Proposed Residential Development  
Land at Chichele Road, Oxted

**Appendices to Proof of Evidence of Andrew  
Whittingham BSc (Hons), MSc, CEng, MICE**

Appeal Reference: APP/M3645/W/24/3345915

Stage 1 Road Safety Audit  
Prepared on behalf of Motion

Guildford - London - Reading www.motion.co.uk	Project: Land Chichele Road, Oxted	
	Title: Proposed Traffic Calming Scheme Central Way	
	Scale: 1:1,000 (@ A3)	
Notes:	Drawing:	Revision:
	1907029-04	Page 18

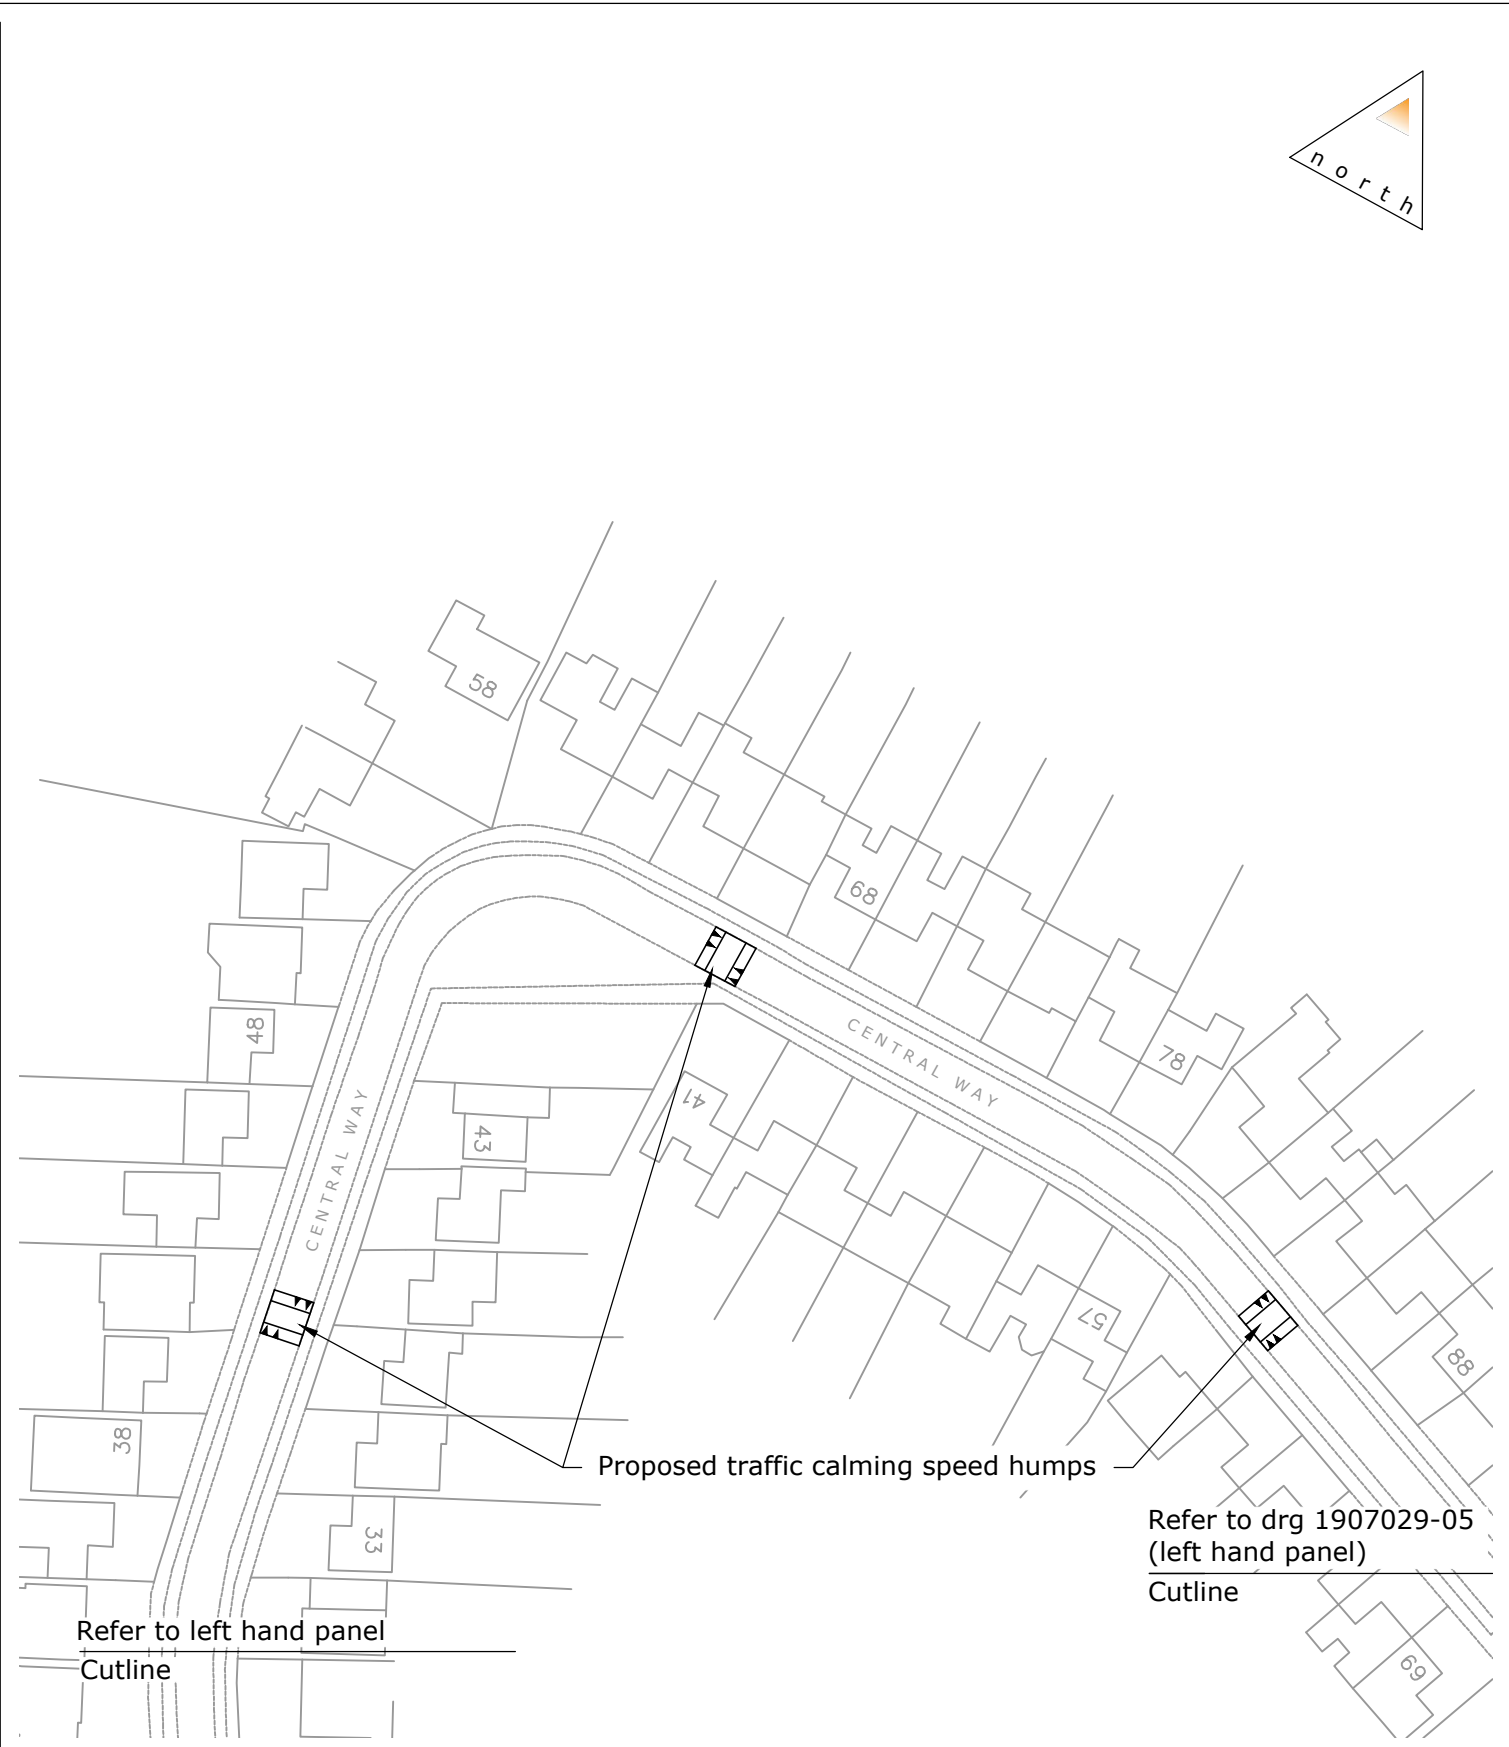
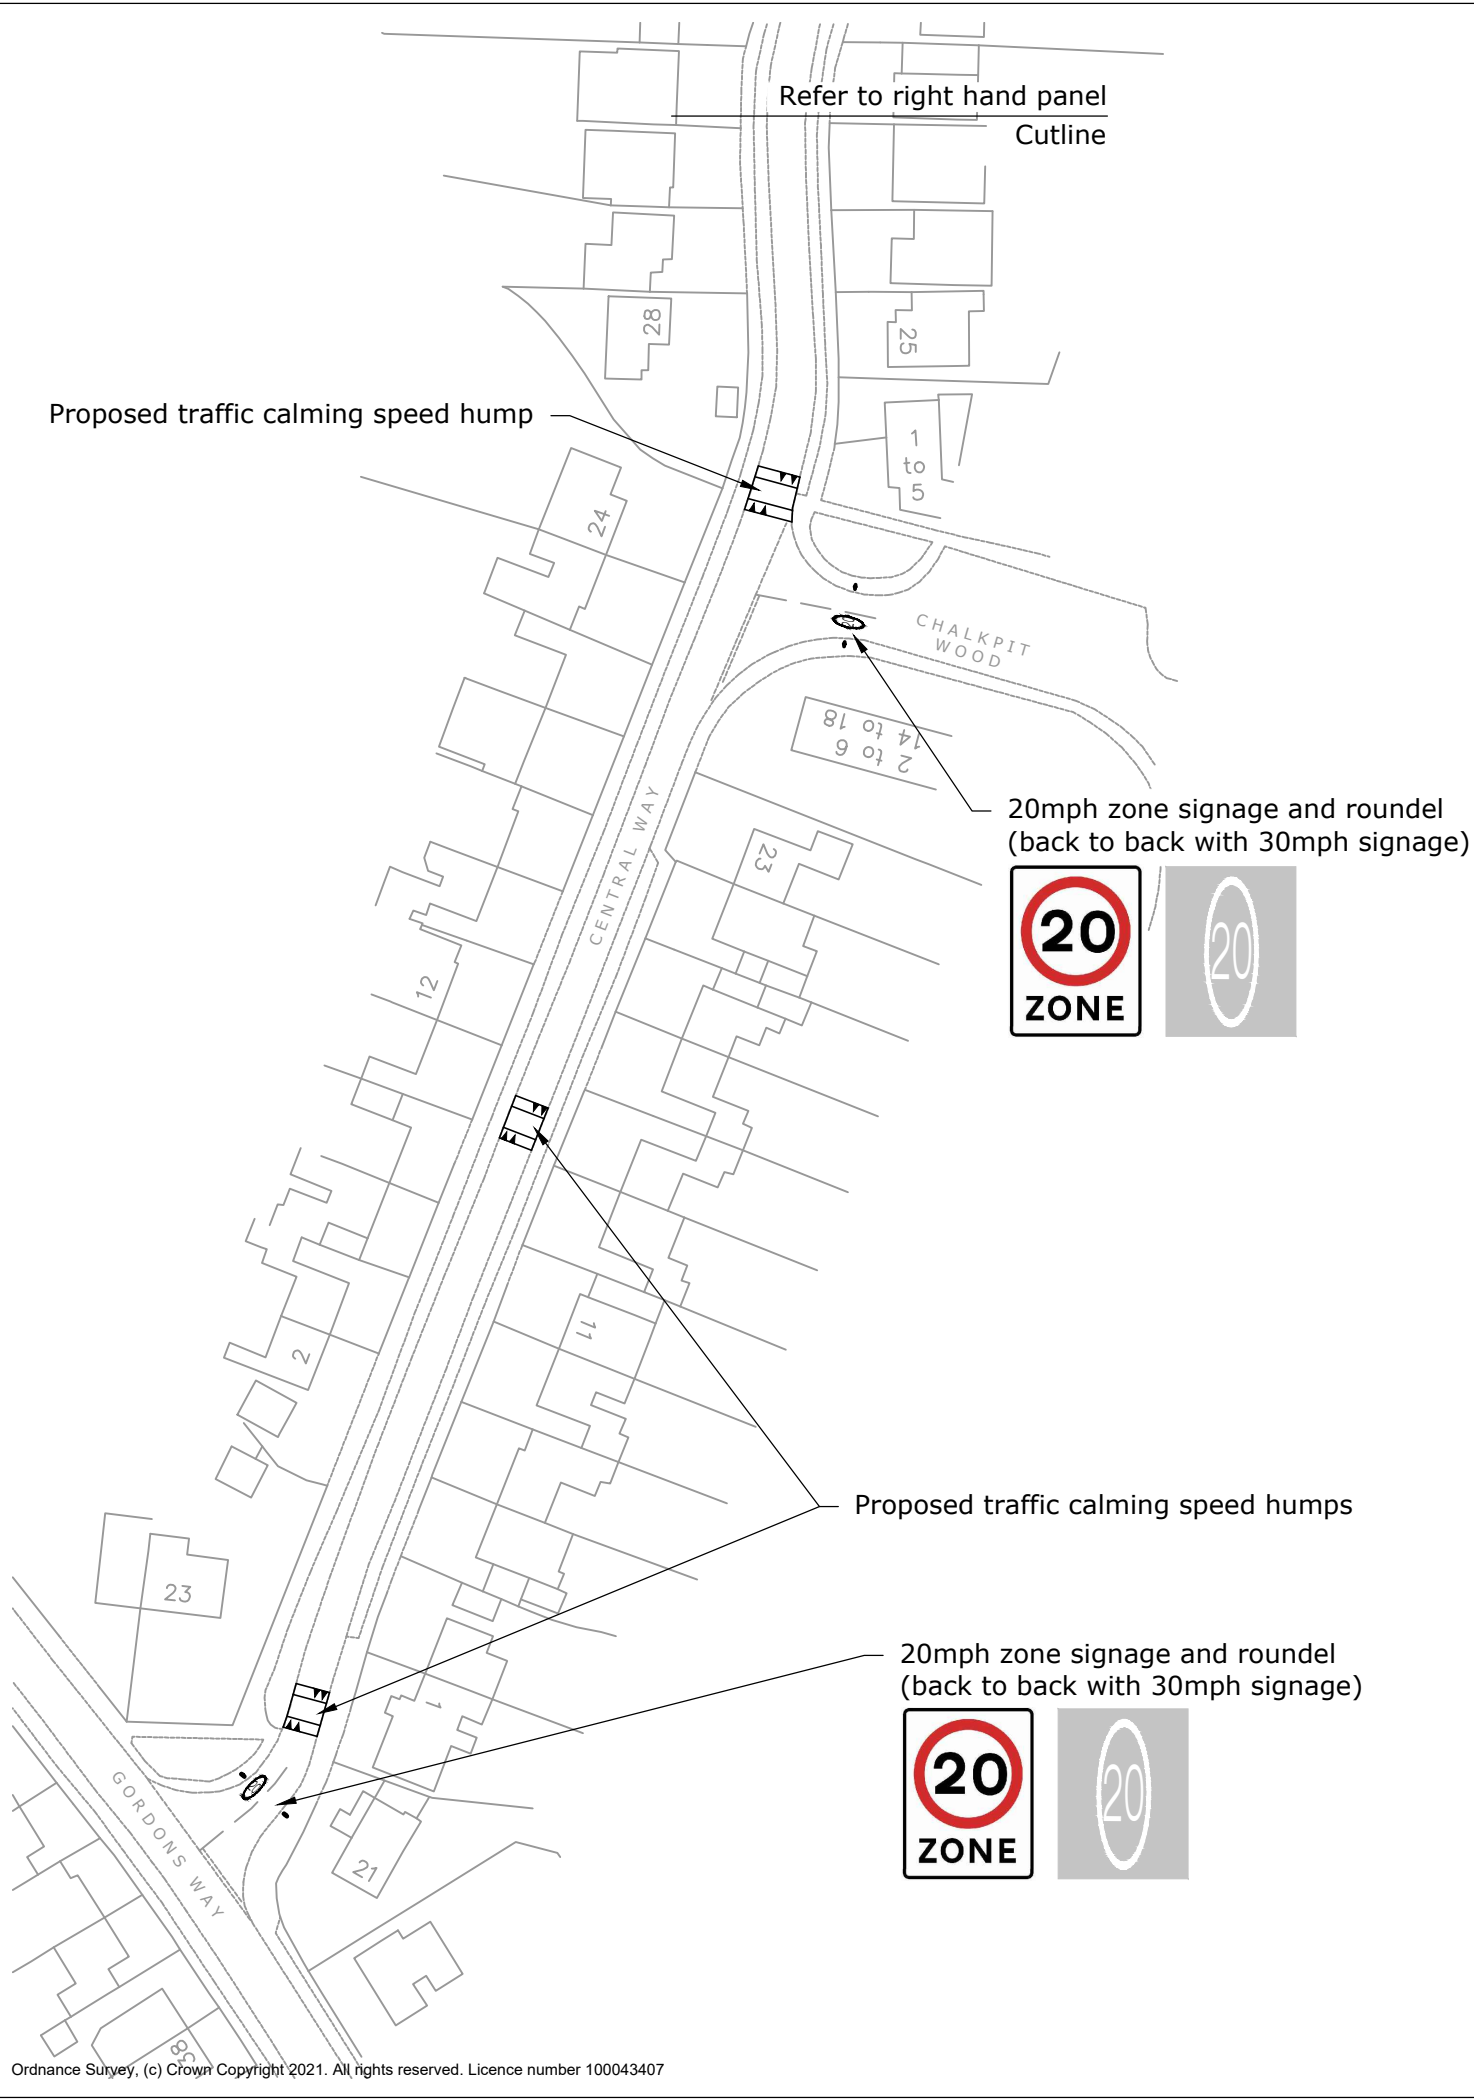
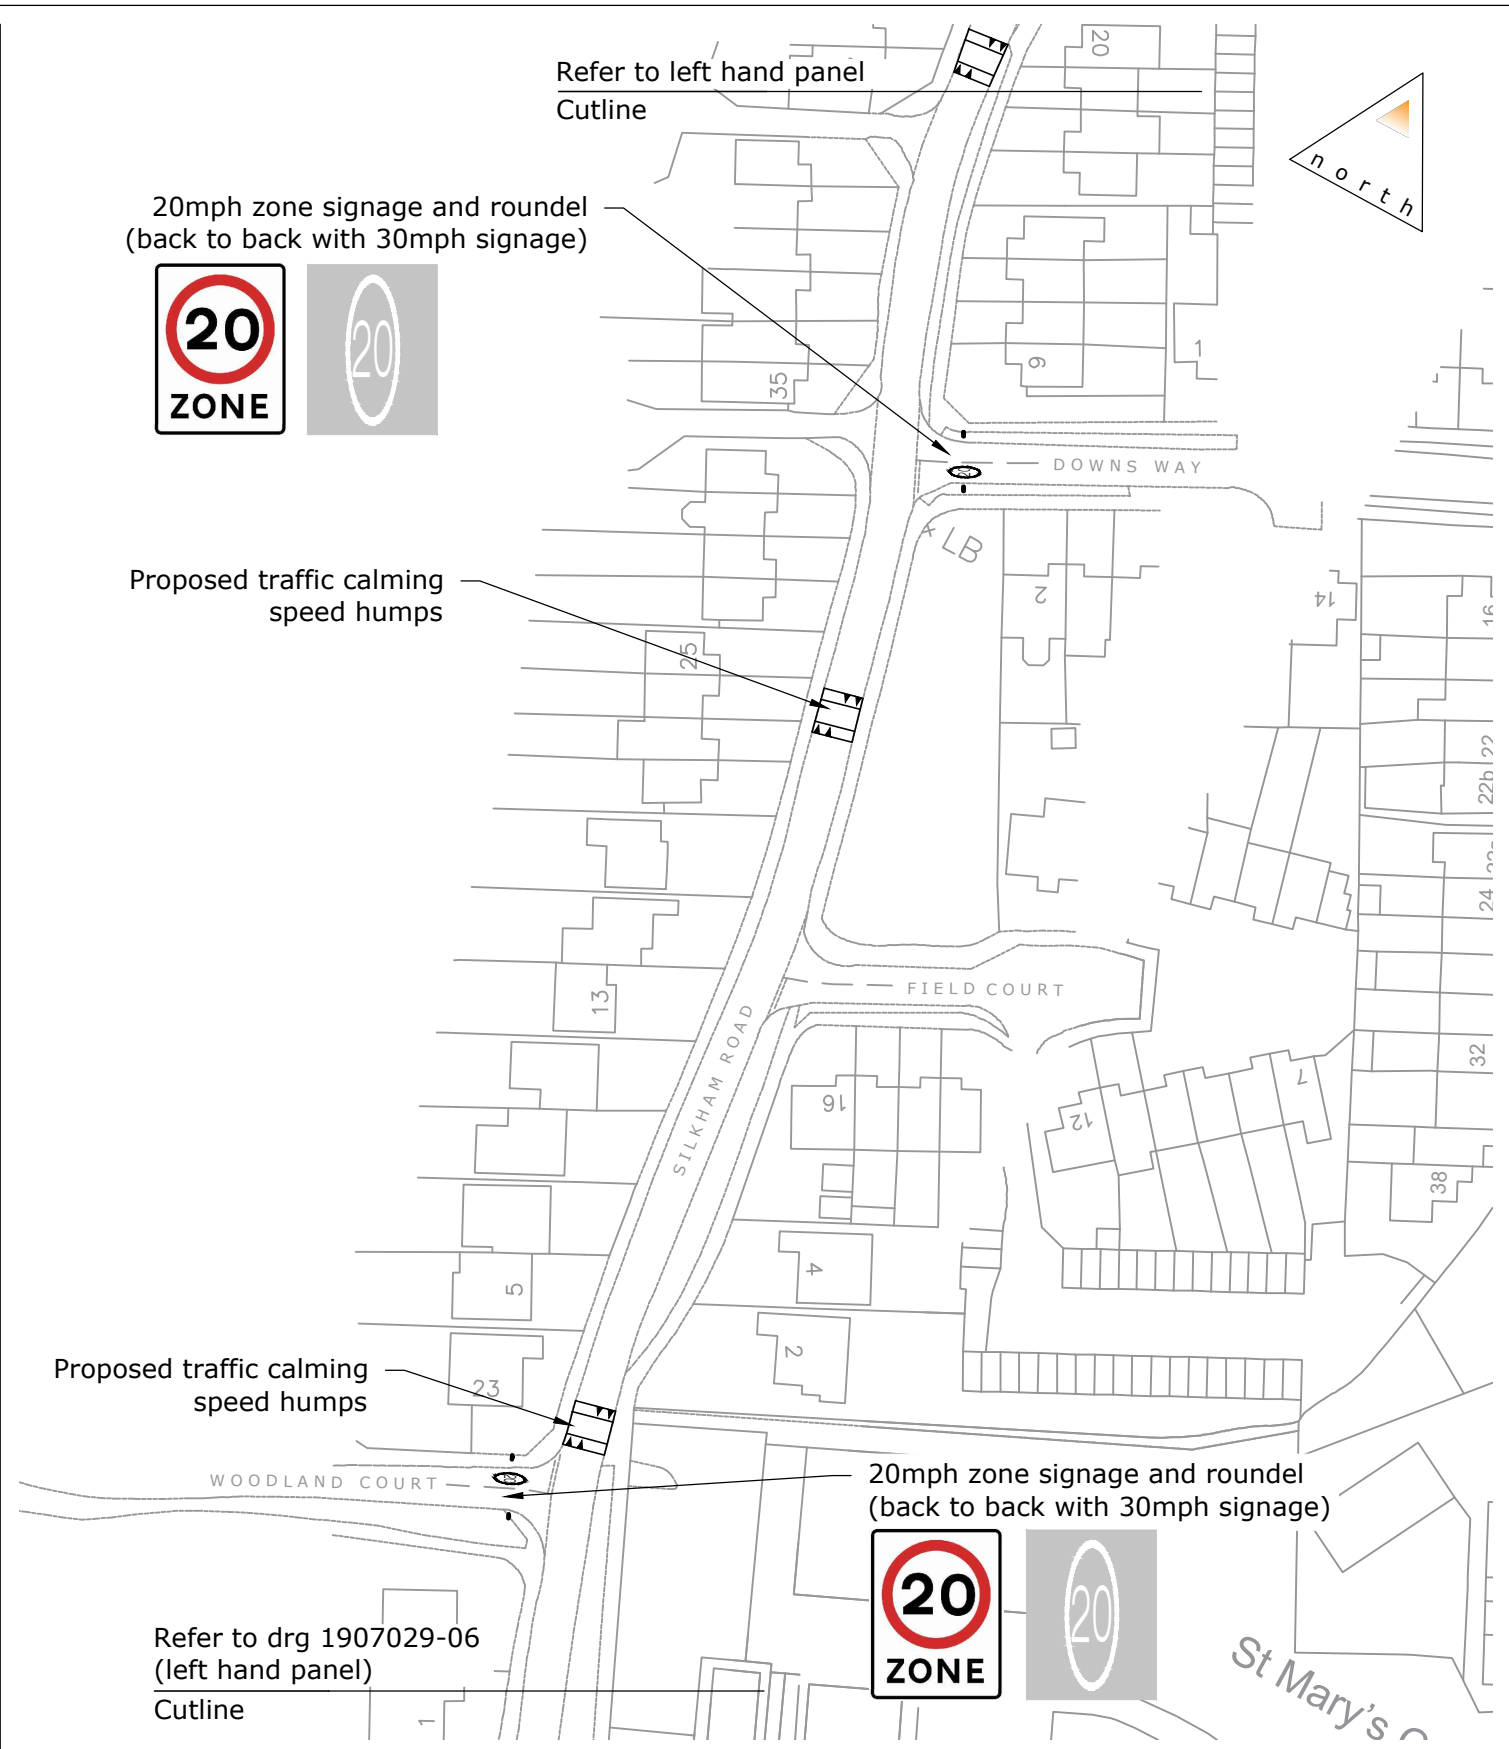
The limited junction separation between Silkham Road and the site access may lead to drivers misinterpreting the signals of turning vehicles. For example, a driver waiting to turn out of Silkham Road may interpret a left turn signal for the site access as a left turn for Silkham Road, leading the non-priority vehicle to pull out into the path of the priority vehicle. Similarly, a right turn signal for the site access may be interpreted as a right turn into Silkham Road, causing a following vehicle on Chichele Road to 'shunt' into the rear of the turning vehicle.

Introduce a local 20mph speed limit to reduce the risk of collisions and the severity of injuries and, if necessary, provide additional traffic calming measures on each approach. Suitable signage of the speed limit and traffic calming features should be provided. It may be appropriate to treat the entire junction arrangement as a raised surface with contrasting surface materials.

2.4	Introduce a local 20mph speed limit to reduce the risk of collisions and the severity of injuries and, if necessary, provide additional traffic calming measures on each approach. Suitable signage of the speed limit and traffic calming features should be provided. It may be appropriate to treat the entire junction arrangement as a raised surface with contrasting surface materials.	The proposals include a potential 20mph speed limit scheme within the vicinity of the site in the form of signage and raised tables along Chichele Road, Silkham Road and Central Way.
